B. THE ABOVE NUMBER CONTRACT/ORDER IS MODIF appropriation date, etc.) SET FORTH IN ITEM C. THIS SUPPLEMENTAL AGREEMENT IS ENTERED IN: D. OTHER (Specify type of modification and authority type) (Specify type) is not, 14. DESCRIPTION OF AMENDMENT/MODIFICATION PROJECT: Modified Record	14, PURSUANT TO THE AUTIO PURSUANT TO AUTHORID DRIVEY	HORITY OF: S document and return clian headings, including istol Range and 25- ort Riley, Kansas a accordance with th	Meter	Zero Firing I ached pages	copie bject matter i Range, PN	is to the issuing of where feasible.)	ffice.

- 1. SOLICITATION NO. DACA41-02-R-0002 is amended as follows:
- a. AMENDMENT 0001:

MODIFIED RECORD FIRING RANGE

Picture 1: Existing Structures

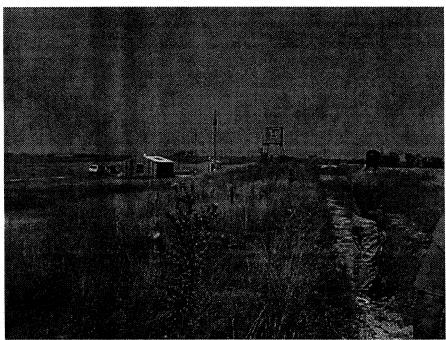
- 3.1. Demolition. Existing facilities scheduled for demolition includes building 941 ammo shed, building 942 latrine, and building 943 tower. Obtain approval of the disposal site from the contracting officer. Demolition shall also include the pavements, equipment, foundations, range lighting, conduit and wiring for target controls, foxholes, target emplacements, and all associated items. PICTURE 1: EXISTING STRUCTURES is attached at the end of this section showing the three buildings to be demolished and the power poles.
